SUBJECT: CATAWBA NUCLEAR STATION, UNITS 1 AND 2 - ISSUANCE OF AMENDMENTS RE: (TAC NOS. MA5989, MA5990)

The amendments revise the minimum reactor coolant system (RCS) flow rate limit, the reactor coolant average temperature, and the pressurizer pressure limits, and restrict operation to a RCS flow deficit of no more than one percent.

Amendment No. 184
License No. NPF-35

Amendment No. 176
License No. NPF-52

Figure 2.1.1-1
Reactor Core Safety Limits
Four Loops in Operation

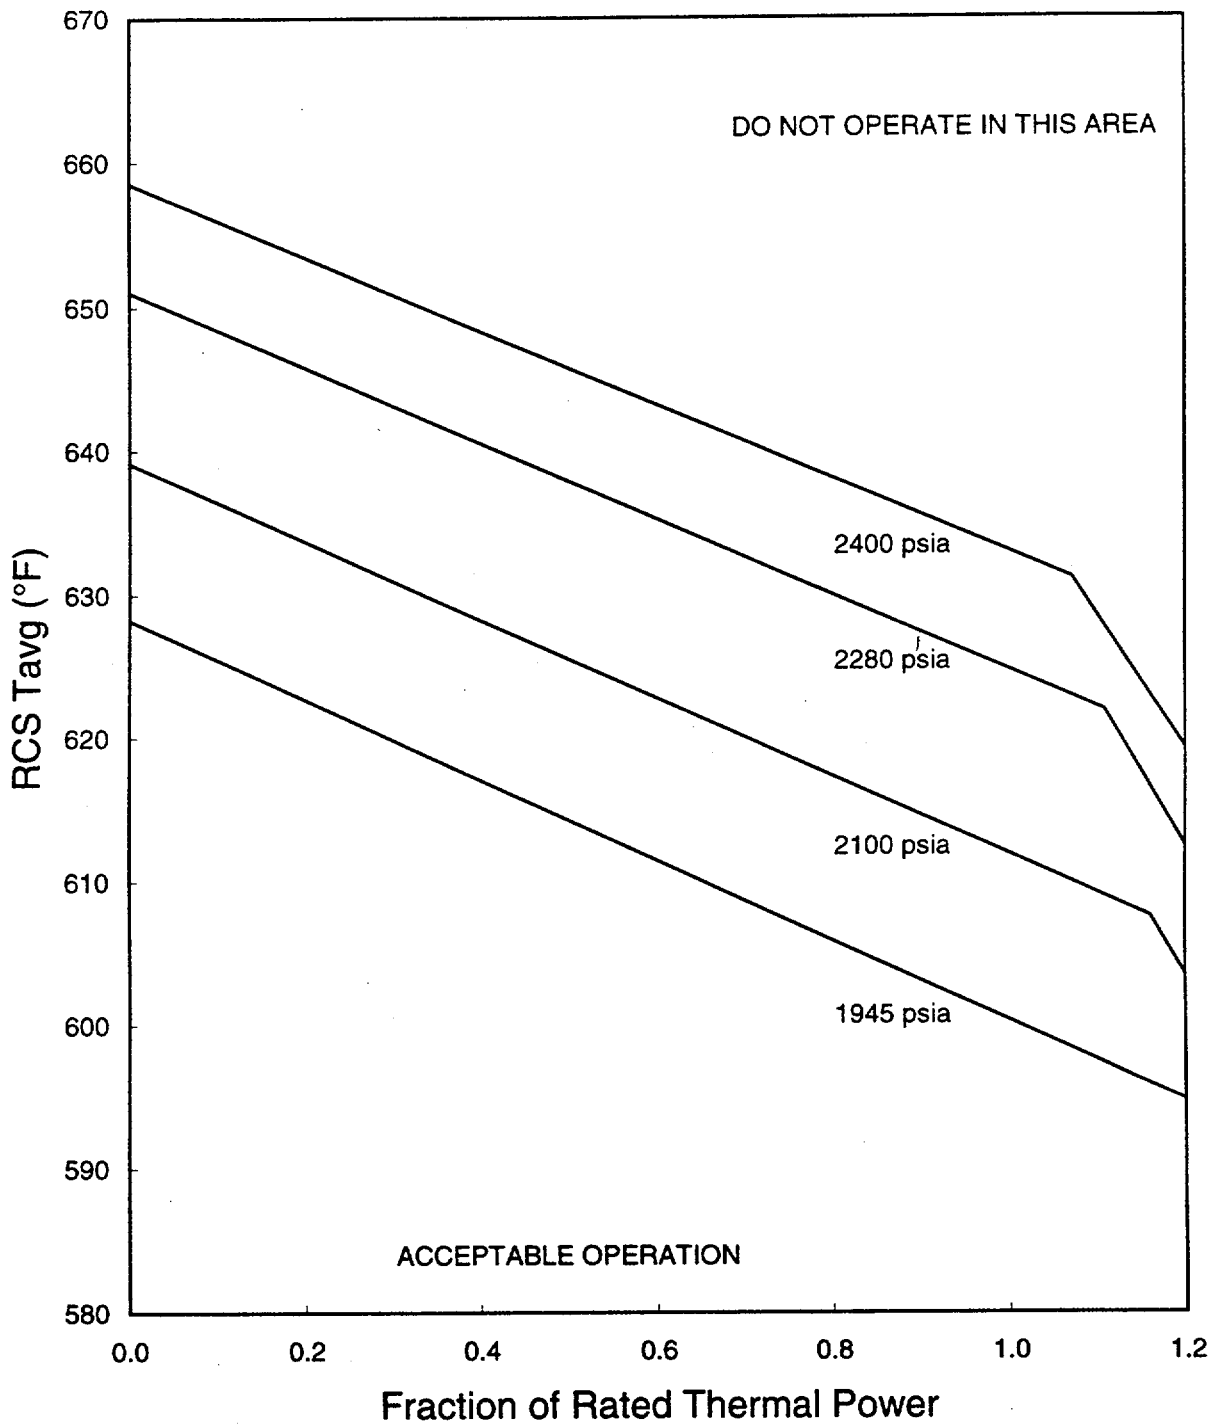
The safety limit curves in TS Figure 2.1.1-1, "Reactor Core Safety Limits - Four Loops in Operation," are revised. The safety limit curves show the loci of points of thermal power, reactor coolant system pressure, and average temperature below which (1) the calculated DNBR is not less than the design DNBR limit or (2) the average enthalpy at the vessel exit is less than or equal to the enthalpy of the saturated liquid. These curves are revised slightly

higher as a result of the increase in the RCS flow limit to 390,000 gpm. The safety limits do not affect the normal operation of the facility, but are only used to determine the need for further safety evaluations following postulated overheating or power excursion transients. Since the axial flux difference limits of LCO 3.2.3 are unchanged, all the current thermal hydraulic design criteria continue to be satisfied. The licensee has determined that the constants in the over-temperature ΔT (OT ΔT) and overpower ΔT (OP ΔT) setpoint equations are conservative and provide the necessary reactor protection. These OT ΔT and OP ΔT reactor trips are assumed in the Chapter 15 analyses.
